# Petition for Post-Certification Change

Construction Laydown Area

Stanton Energy Reliability Center

16-AFC-1

**Figure 1**  
Proposed Construction Laydown Area  
Stanton Energy Reliability Center  
Stanton, CA

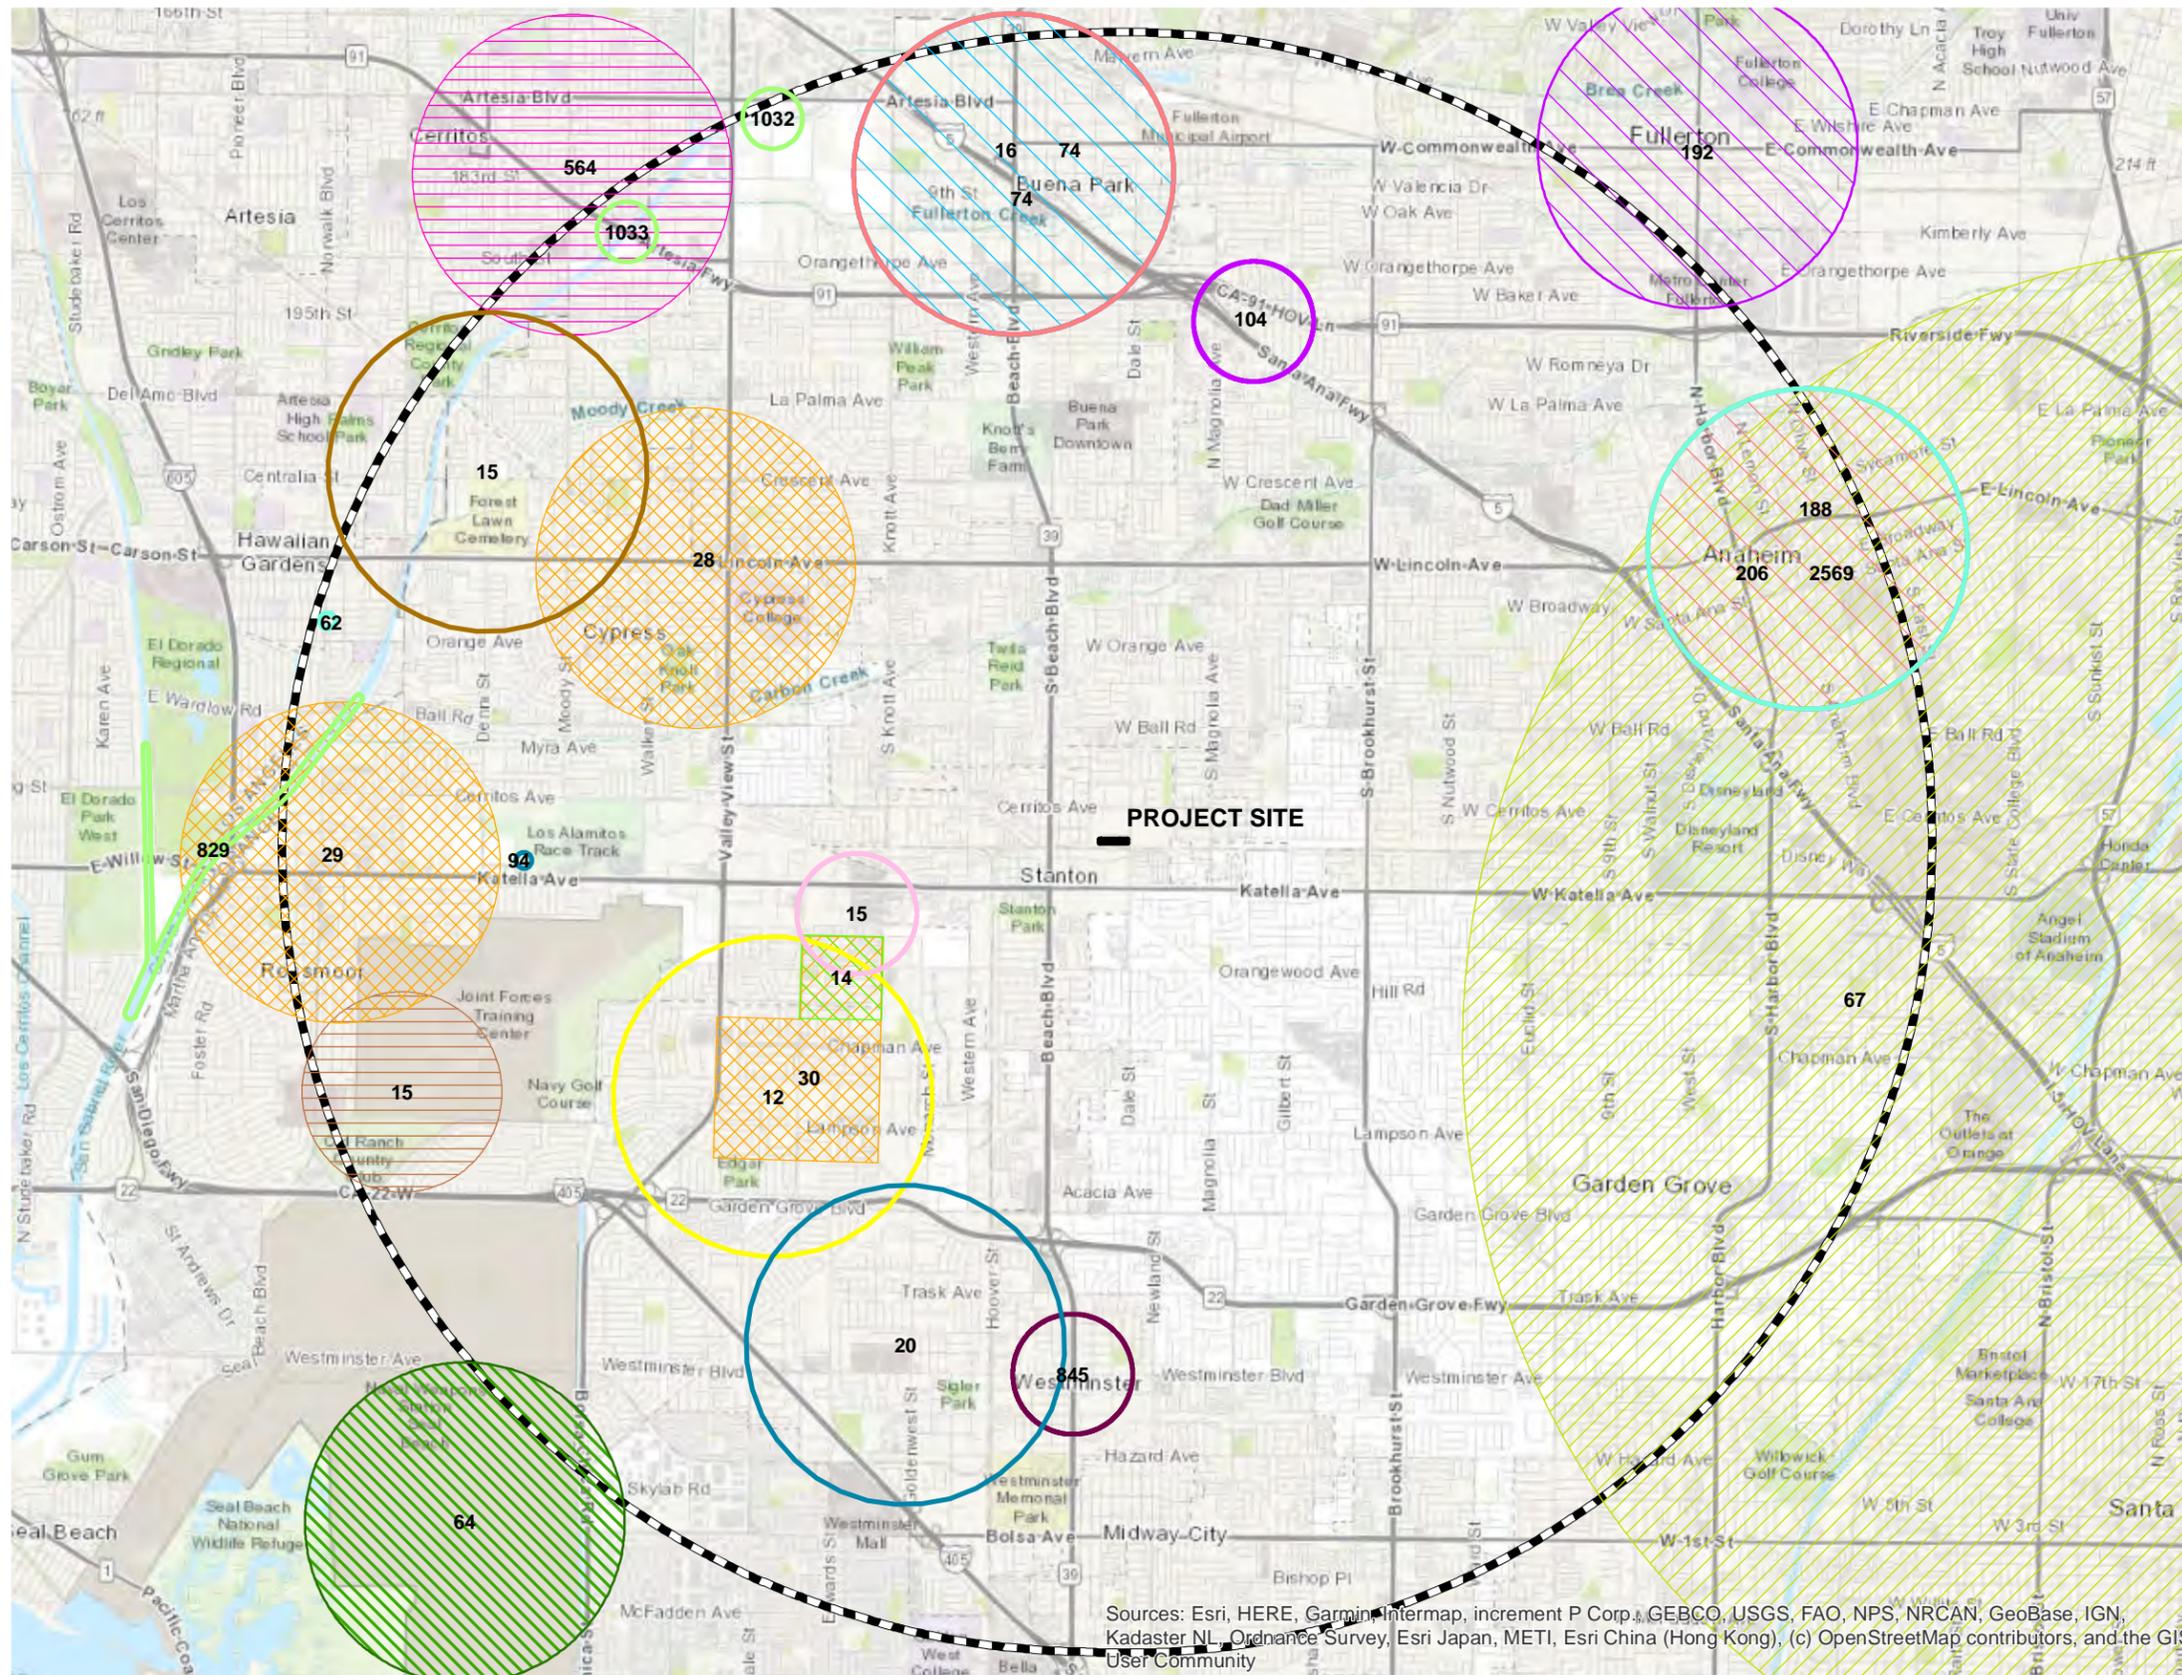
Consistent with CEC Siting Regulations (Title 20, CCR, Section 1769 [a][1][A]), this section includes a description of the proposed project change. This Petition proposes modifying the SERC license to include additional construction laydown, parking, and staging area that will be used for temporarily for construction and not for operation. The proposed construction laydown area is adjacent to and north of SERC project site parcels 1 and 2. This 2.64-acre property is owned by Southern California Edison Company (SCE) and consists of the following Assessor's Parcel:

The project owner has designated a roadway 16-feet-wide along the southern boundary of the laydown parcels to provide access to two SCE transmission towers on the western parcel. By agreement with SCE, a 50-foot x 50-foot buffer area will be established around each of the two tower bases on the western parcel. Concrete k-rail will be placed around the tower bases to protect these from inadvertent vehicle collision.

The portion of the laydown area furthest east and facing Dale Avenue will be for the use of SoCalGas as they construct the natural gas pipeline to the project. This portion will cover 0.9 acres (including the 16-foot-wide access lane). The remainder of the area will be for SERC construction (1.74 acres). A temporary fence will be erected to separate these two areas.

A fence will be erected between the new laydown areas and the SERC construction site. Two 16-foot-wide gates will be placed into this fence: one in the western parcel and one in the eastern parcel.
